COMMUNITY DEVELOPMENT
DEPARTMENT REPORT

HEARING DATE: 10/3/2024
TO: Planning & Zoning Commission
FROM: Bill Parsons, Current Planning Supervisor 208-884-5533
shersh@meridiancity.org
APPLICANT: Jorre Delgado, JD Planning & Consulting
SUBJECT: H-2023-0070
Rolling Hill - AZ, CUP
LOCATION: 1560 Rolling Hill Drive (Parcel # R7555000032), 1520 Rolling Hill Drive (Parcel #R7555000041), 1480 Rolling Hill Drive (Parcel #R7555000050), 4270 Rolling Hill Drive (Parcel #R7555000015) and Parcel #R7555000025 in the SW 1/4 of the SE 1/4 of Section 16, T.3N., R.1E.

Annexation of 6.90 acres of land from the R-1 zone in Ada County to the C-C (Community Business District district) zone to develop two (2) vertically integrated residential structures featuring 90 dwelling units and 20,134 square feet of commercial space; conditional use permit to develop one (1) multi-family building consisting of 64 dwelling units on 5.89 acres in the proposed C-C zone. **NOTE: The CUP is only required the multi-family portion of this development. Vertically integrated residential projects are listed as principally permitted uses in the C-C zone.**

C. Site Plan

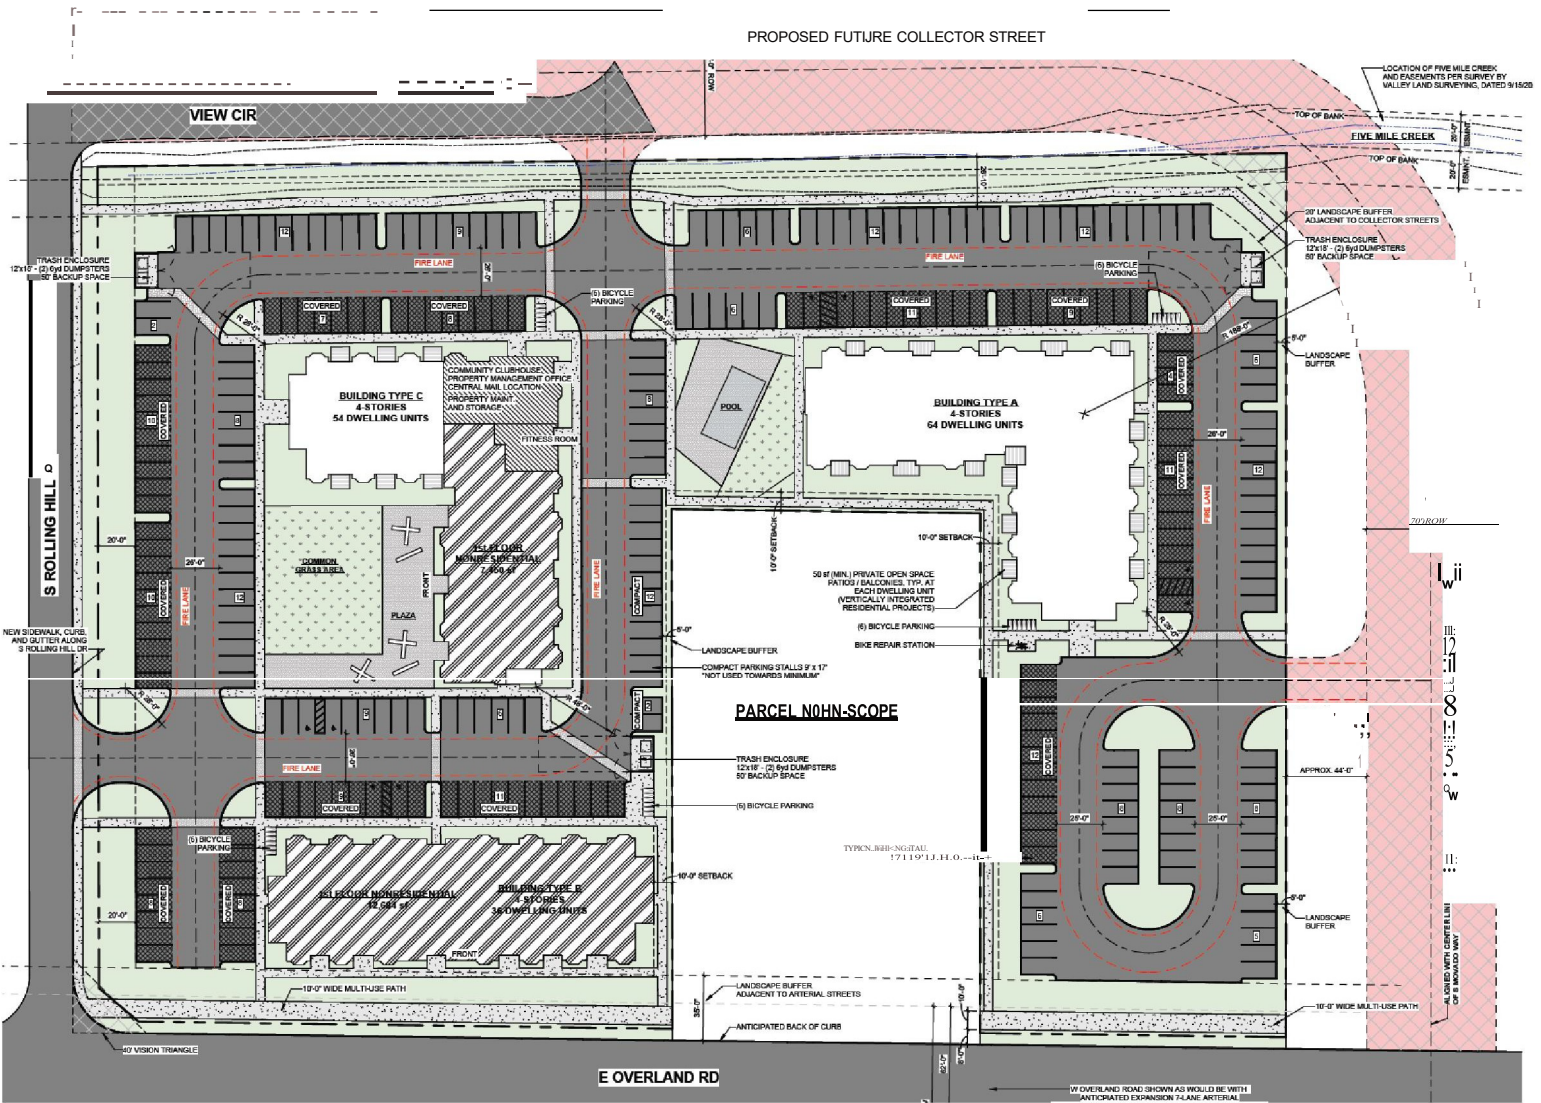
The applicant has worked with the City of Meridian to determine an alignment of the new collector roadway, as shown below. To accommodate the future construction of the collector, the applicant should be required to dedicate right-of-way at the site's northeast property line, as shown on the site plan below.

6. Dedicate right-of-way abutting the site's northeast property line to accommodate the future construction of a planned collector roadway, as shown in site plan on page 8.

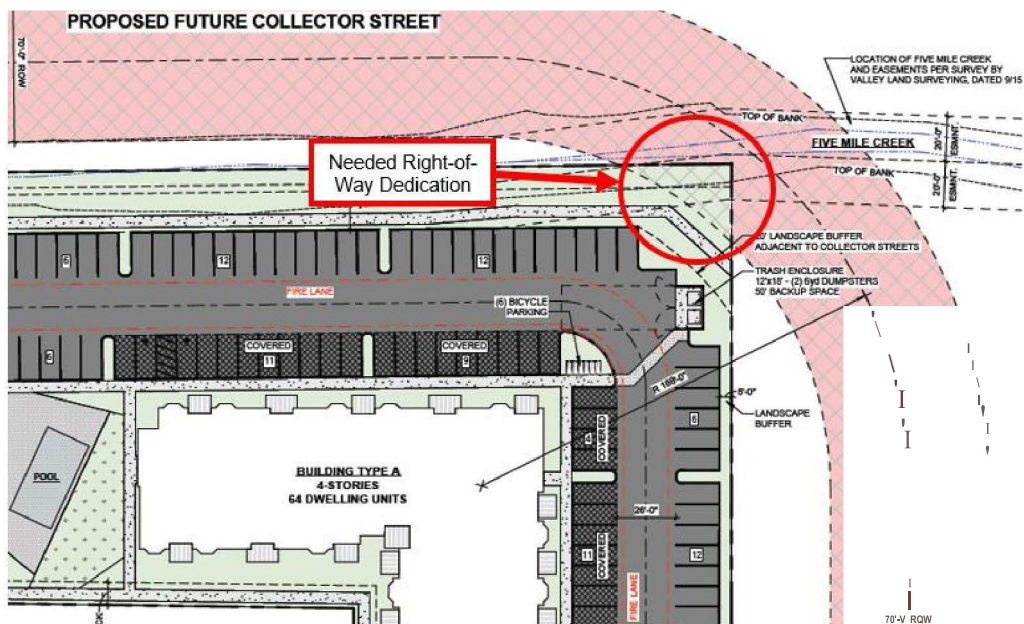
- b. Applicant Proposal:** The applicant is not proposing any improvements to View Circle abutting the site.
- c. Staff Comments/Recommendations:** The applicant's proposal does not meet District policy and should not be approved, as proposed. The applicant should be required to construct View Circle as ½ of a 36-foot wide collector roadway with curb, gutter, and a minimum of 7-foot attached sidewalk or 5-foot wide detached sidewalk with an 8-foot wide planter strip from Rolling Hill Drive to the existing terminus of View Circle 350-feet east of Rolling Hill Drive.

The applicant should be required to dedicate right-of-way to extend 2-feet behind back of sidewalk.

5. Construct View Circle as $\frac{1}{2}$ of a 36-foot wide residential collector roadway with curb, gutter, and a minimum of 7-foot attached sidewalk or 5-foot wide detached sidewalk with an 8-foot wide planter strip.

E. Site Plan (date: 5/21/2024)

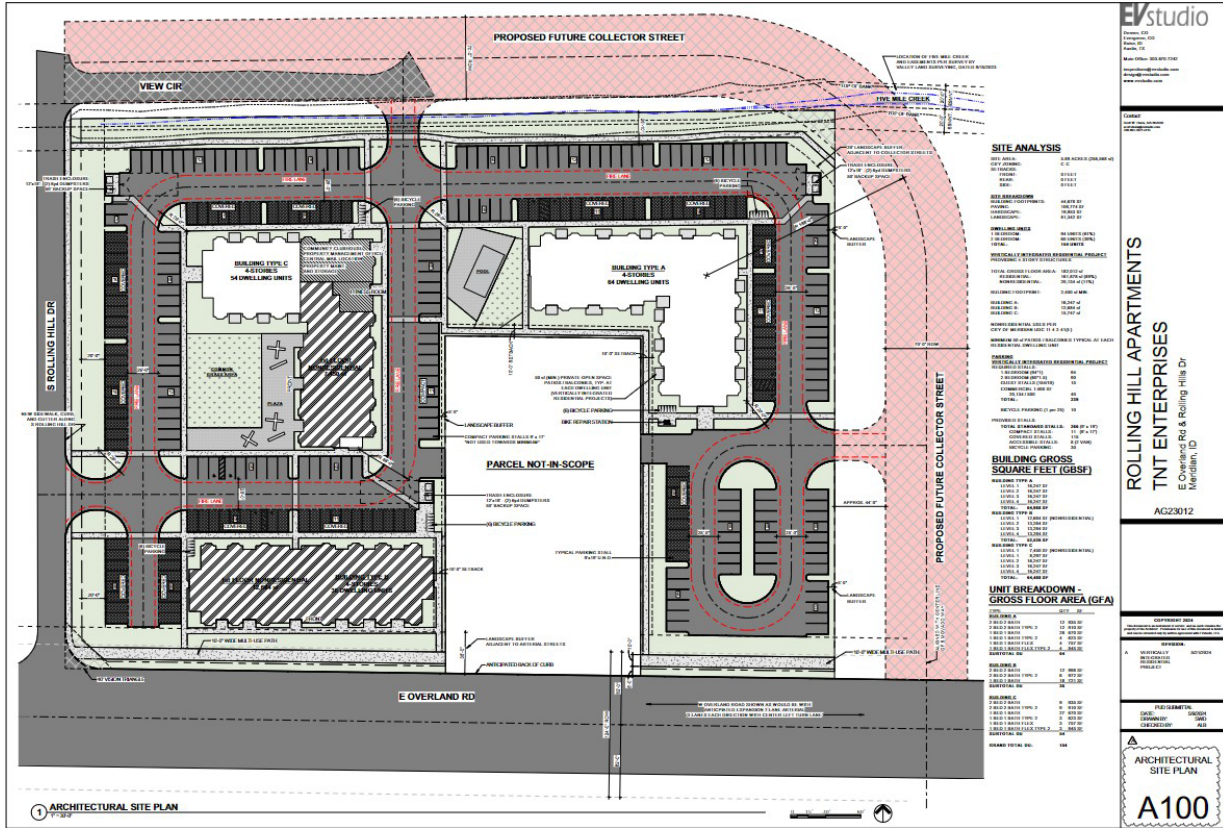
Additionally, the Applicant has extended the drive aisles and pedestrian connections for cross-access to the out-parcel within the center of this development. Staff would like to see the drive aisles stubbed to this parcel line-up directly across from each other for easier vehicle maneuvering. Furthermore, Staff recommends that the Applicant revise the landscape plan to include cross-access to the outparcel to match the site plan.

- f. Shift Building C and the associated parking 2 -feet to the west, to eliminate the compact parking stalls and provide standard 9 x 19 parking stalls.

2. The trash enclosures shall contain receptacles to accommodate recycling.
3. Compliance with the specific use standards listed in UDC 11-4-3-27 for Multi-family Developments is required.
4. The site plan shall be revised as follows:
 - a. Depict a directory and map of the development at each of the entrances or in a convenient location for those entering the development in accord with UDC 11-4-3-27B.7d.
 - b. Include the building setbacks on the plans submitted with the future CZC application.
 - c. Align the drive aisles stubbed to the outparcel directly across from each other for easier vehicle maneuvering.

F. Landscape Plan (date: 5/23/2024)

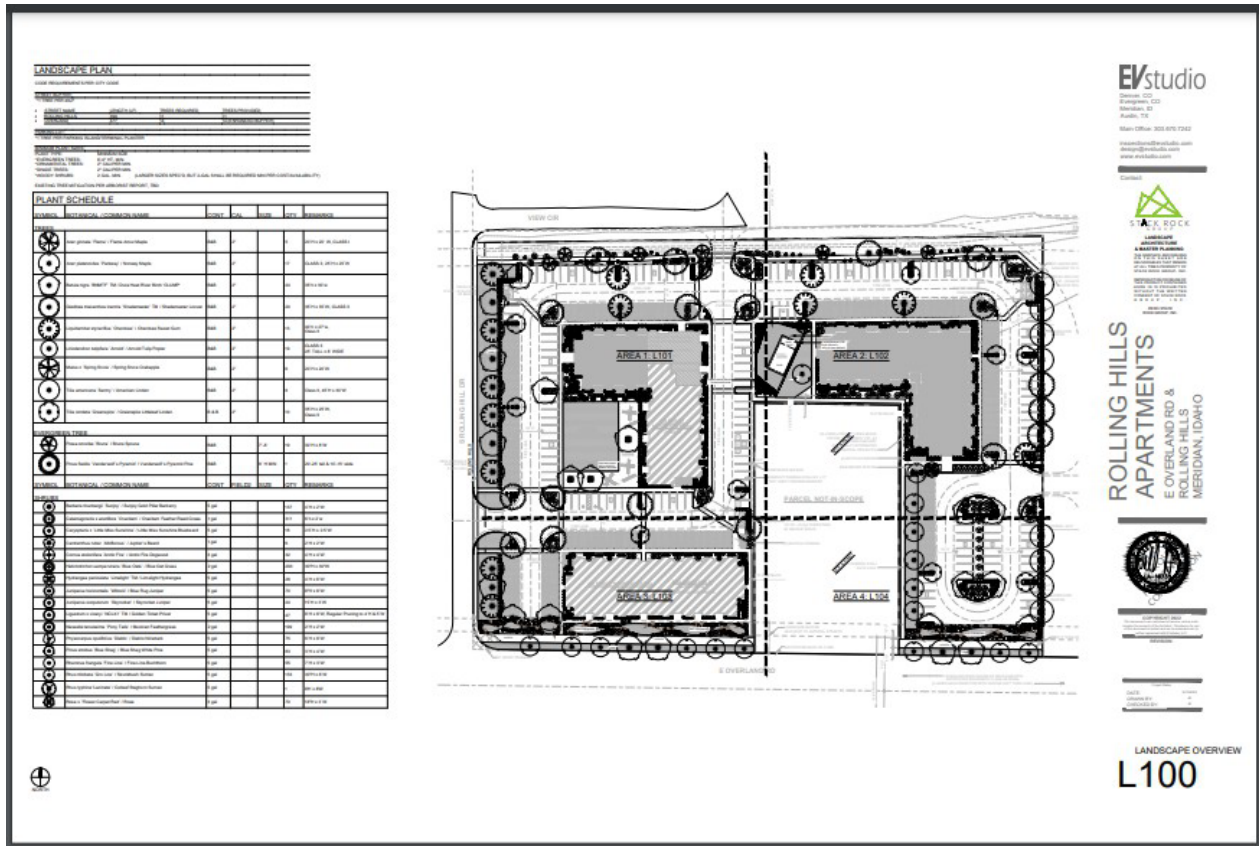
Staff recommends that the proposed pathway provided along the northern boundary adjacent to the Five Mile Creek be widened to 10-feet in width as required by the Meridian Master Pathways Plan.

Staff recommends that the Applicant include tree mitigation notes on the Landscape plan submitted with the future CZC Application.

13. The landscape plan shall be revised as follows:
- a. The proposed pathway provided along the northern boundary adjacent to the Five Mile Creek shall be widened to 10-feet in width as required by the Meridian Master Pathways Plan.

- b. Specify the type of lawn and dry creek rock in the plat schedule on the landscape plan submitted with the future CZC Application.
 - c. Add a picnic area that includes tables, benches, and a structure for shade in the open space grassy area by the pool to enhance recreational options for the residents.

- d. Revise the landscape plan to include cross-access to the outparcel to match the site plan.
 - e. Install a 6-foot non-scalable wrought iron fence as a safety barrier around the pool, in compliance with the International Swimming Pool and Spa Code, and provide a detail of the fencing on the plans submitted with the future CZC application.

- f. Include tree mitigation notes on the Landscape plan submitted with the future CZC Application.
 - g. A 10-foot wide detached sidewalk/multi-use pathway shall be along the northern boundary adjacent to the Five Mile Creek as required by the Meridian Master Pathways Plan.
